REPORT TO CORE AREA LIQUID WASTE MANAGEMENT COMMITTEE MEETING OF WEDNESDAY, NOVEMBER 13, 2013

SUBJECT TECHNICAL AND COMMUNITY ADVISORY COMMITTEE REVIEW OF CORE AREA LIQUID WASTE MANAGEMENT PLAN DRAFT AMENDMENT

DRAFT AMENDMENT NO. 9 TO THE CORE AREA LIQUID WASTE MANAGEMENT PLAN - CORE AREA WASTEWATER TREATMENT PROGRAM

DRAFT AMENDMENT NO. 9 – SUMMARY

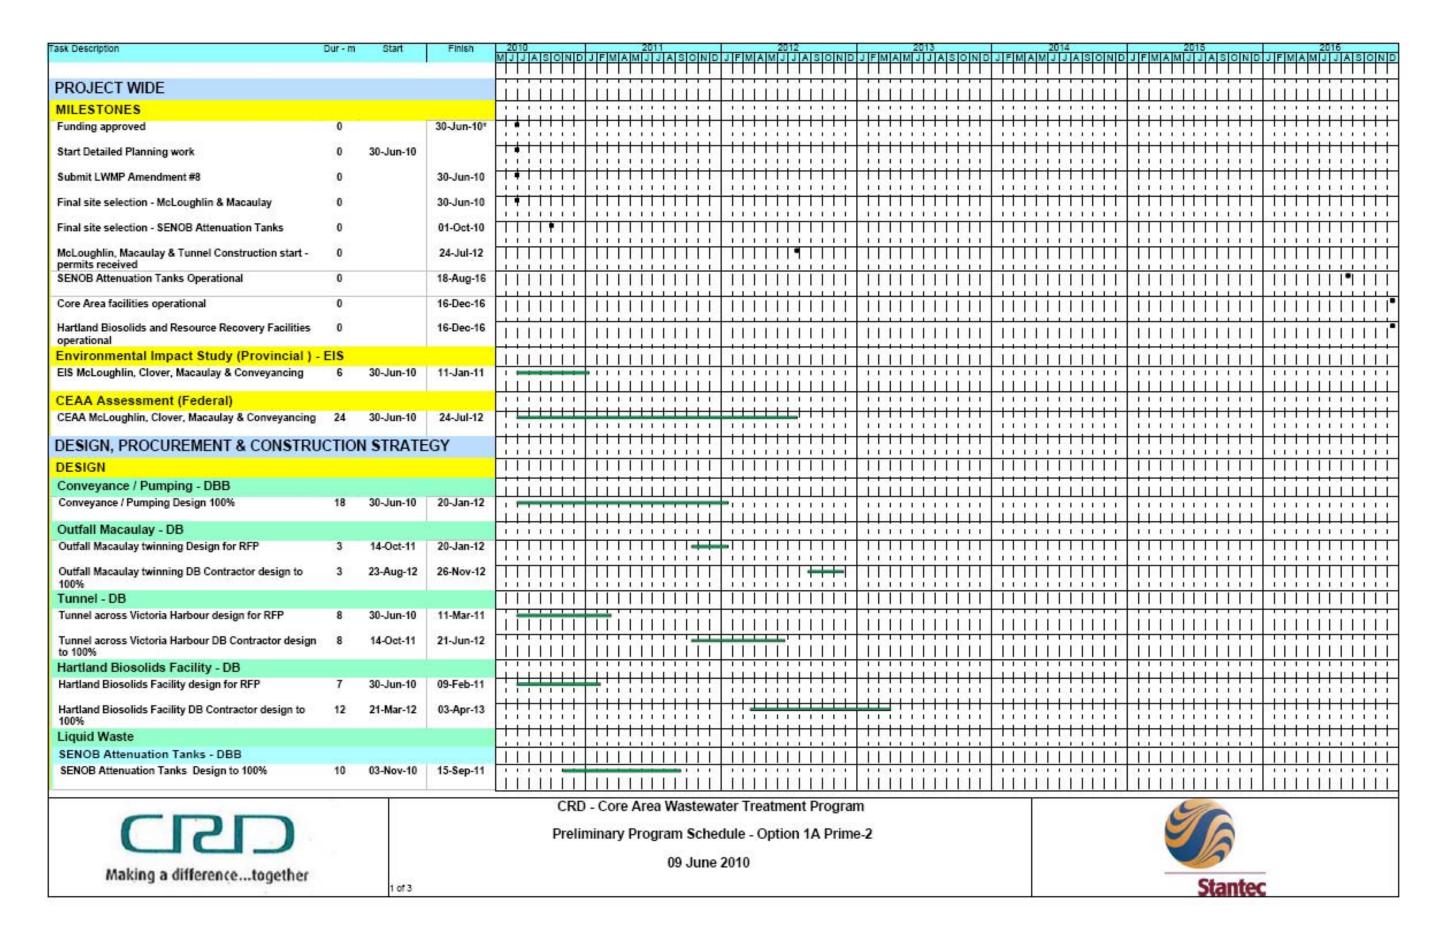
Amend page 1.2 of Section 1 by deleting "As indicated in figure 6.1A, a 12,000 m³ wet weather flow attenuation tank will be constructed at Arbutus Road in Saanich." and replacing it with "As indicated in figure 6.1A, a 5,000 m³ wet weather flow attenuation tank will be constructed at Arbutus Road in Saanich." The revised figure 6.1A is attached as Appendix 3.
